ceived by OCDS/21/2023 4:16:10 PM U.S. Department of the Interior BUREAU OF LAND MANAGEMENT		Sundry Print Report
Well Name: POKER LAKE UNIT	Well Location: T24S / R29E / SEC 13 / SWNE /	County or Parish/State: EDDY / NM
Well Number: 276	Type of Well: OIL WELL	Allottee or Tribe Name:
Lease Number: NMNM05912	Unit or CA Name: POKER LAKE DELAWARE C	Unit or CA Number: NMNM71016G
US Well Number: 3001535137	Well Status: Producing Oil Well	Operator: XTO PERMIAN OPERATING LLC

Sundry ID: 2737916

Sundry ID: 2737909

PLUG AND ABANDON WELLBORE POKER LAKE UNIT 274 EDDY COUNTY, NEW MEXICO Class II

PLU 274 - Proposed WBD

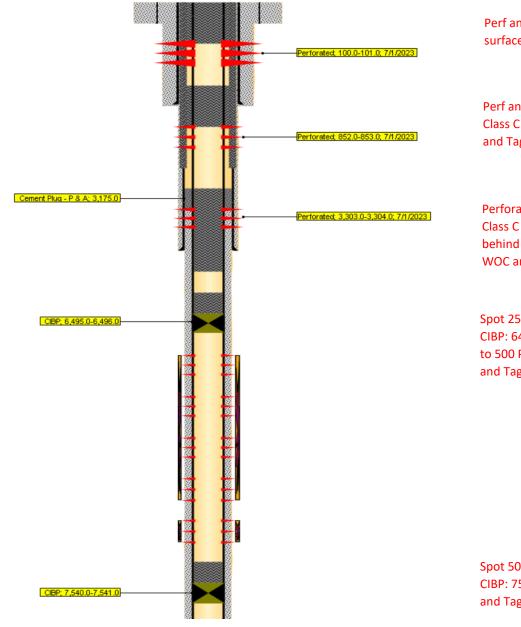
Perf and circulate 100' to surface.

Perf and squeeze 25 SKS Class C: 852' to 685'. WOC and Tag.

Perforate at 3033, spot 30 SKS Class C from 3392', and displace behind casing for TOC at 3175', WOC and Tag.

Spot 25 SKS Class C atop CIBP: 6495' to 6117'. PT CIBP to 500 PSIG for 30 min. WOC and Tag.

Spot 50 SKS **Class H** atop CIBP: 7540' to 6974'. WOC and Tag.
